APPEAL SUMMARY

Status: Decision Rendered**Appeal ID:** 15816**Project Address:** 1414 SW Park Ave**Hearing Date:** 9/13/17**Appellant Name:** Eric Buschert**Case No.:** B-010**Appellant Phone:** 503-224-9656**Appeal Type:** Building**Plans Examiner/Inspector:** Natalie Davis**Project Type:** commercial**Stories:** 7 **Occupancy:** R-2, S-2 **Construction Type:** I-A, III-A**Building/Business Name:****Fire Sprinklers:** Yes - entire building**Appeal Involves:** Erection of a new structure**LUR or Permit Application No.:** 17-152022-CO**Plan Submitted Option:** pdf [File 1] [File 2] [File 3] [File 4]**Proposed use:** Multi-family housing (apartments)

There is no previously tested assembly for the floor-ceiling assembly between our L07 roof terrace and the L06 unit directly below it. The attached analysis from our acoustical engineer, Listen Acoustics, demonstrates that the assembly will meet STC 61 and IIC 53, exceeding the code minimum of 50 for each.

L06-07 Section

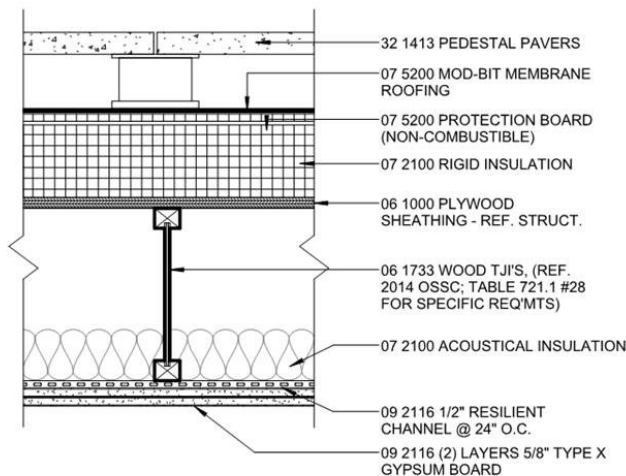
floor-ceiling assembly in
question between L07 roof
terrace and L06 unit below

Sound transmission ratings (STC / IIC) for 1 hour rated roof / ceiling assembly at roof terrace and unit below per Acoustical Engineer's analysis: Granted as proposed.

R2

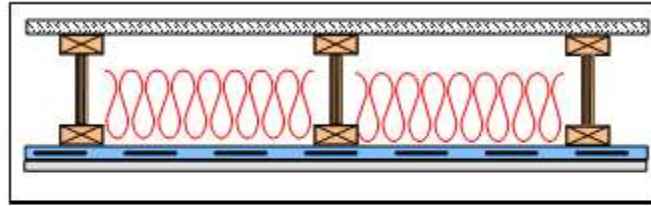
There is no test of this exact assembly, but based on our professional analysis of the a base assembly, plus modifiers as discussed below, the assembly exceeds the STC 50 and IIC 50 minimums.

- The comparable base assembly has OSB/Plywood sheathing on top, TJI, RC channel and ONE layer gwb. The Test # from NRC IRC is: **Test #TLF-96-069a**

- The rating for this comparable base assembly is STC 51 and IIC 45

STC Additions:

1. Concrete Pavers, 1" min thick, plus air gap, +4 STC points;
2. Protection board + rigid insulation, +4 STC points
3. Added 5/8" gwb layer, +2 STC points

IIC Additions:

1. Rigid insulation with protection board, +6 IIC points
2. Added 5/8" gwb layer, +2 IIC points

Therefore, the calculated resulting STC is at least STC 61 and the calculated resulting IIC rating is at least IIC 53. For best results, we recommend adding rubber pads under the paver pedestals will increase the IIC by an additional 11 points, to ensure reduced footfall noise.
